Application for a Certificate of Public Convenience and Necessity (CPCN) for the Tilbury Liquefied Natural Gas (LNG) Storage expansion (TLSE) Project (Application)

Response to the British Columbia Utilities Commission (BCUC) CONFIDENTIAL Information Request (IR) No. 2

Response to British Columbia Utilities Commission (BCUC) CONFIDENTIAL Information Request (IR) No. 2

2 Exhibit B-1-1, Appendix M-1, Schedule 9

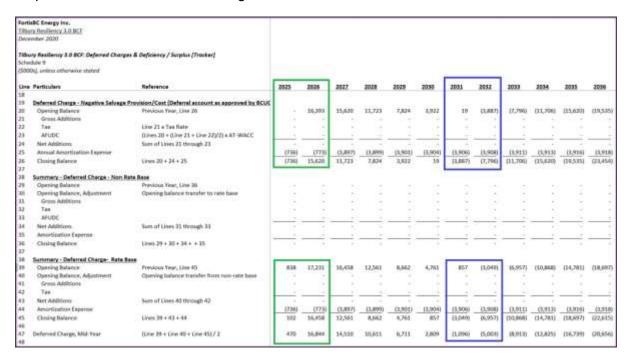
21.1 Please confirm, or explain otherwise, that the increase in opening balances between year 2025 to year 2026 (Line 20 and Line 39) is due to the demolition of the Tilbury Base Plant occurring in 2025.

While responding to this IR, FEI discovered an Excel formula error on Schedule 9 of Confidential Appendix M-1. The 2025 opening balance on Line 39 should have been zero instead of \$0.838 million. The error is relatively minor with a revised levelized delivery rate impact over the 67-year analysis period estimated at 6.66 percent instead of 6.67 percent. The estimated delivery rate impact in 2027, when all assets enter FEI's rate base, remains at 9.07 percent when rounded to two decimal places. Please refer to Confidential Attachment 21.1 for the revised Schedule 9 of Confidential Appendix M-1. Please also refer to the reproduced screenshot below as referenced in the preamble, but reflecting the revised Schedule 9 of Confidential Appendix M-1.

For clarity, Lines 20 to 26 of Schedule 9 show the continuity of the Negative Salvage deferral account as approved by Order G-44-12, while Lines 39 to 45 show the aggregate continuity of all rate base deferral accounts impacted by the proposed TLSE Project which includes the proposed Application and Preliminary Stage Development Costs deferral account (i.e., Lines 2 to 17 of Schedule 9) and the aforementioned Negative Salvage deferral account. FEI notes, starting from 2025, Lines 20 to 26 and Lines 39 to 45 are the same under the revised Schedule 9 (as shown in the screenshot above). This is because, as shown in the financial analysis, the Application and Preliminary Stage Development Costs deferral account would be fully amortized at the end of 2024 and, as such, the opening balance for 2025 on Line 39 is zero.

For the Negative Salvage deferral account, the 2026 opening balance of \$16.393 million shown on Line 20 is the combination of the demolition costs of \$17.129 million in as-spent dollars as shown in Table 6-2 of the Application (Line 6, Column 5) and the 2025 ending credit balance of \$0.736 million (i.e., \$17.129 million - \$0.736 million = \$16.393 million). FEI notes, similar to capital expenditures for CPCNs, the demolition costs are shown to enter the deferral account on January 1 as an opening balance adjustment³ following the completion of the demolition (i.e., the Base Plant demolition is estimated to be complete in 2025 therefore it is shown as an opening balance
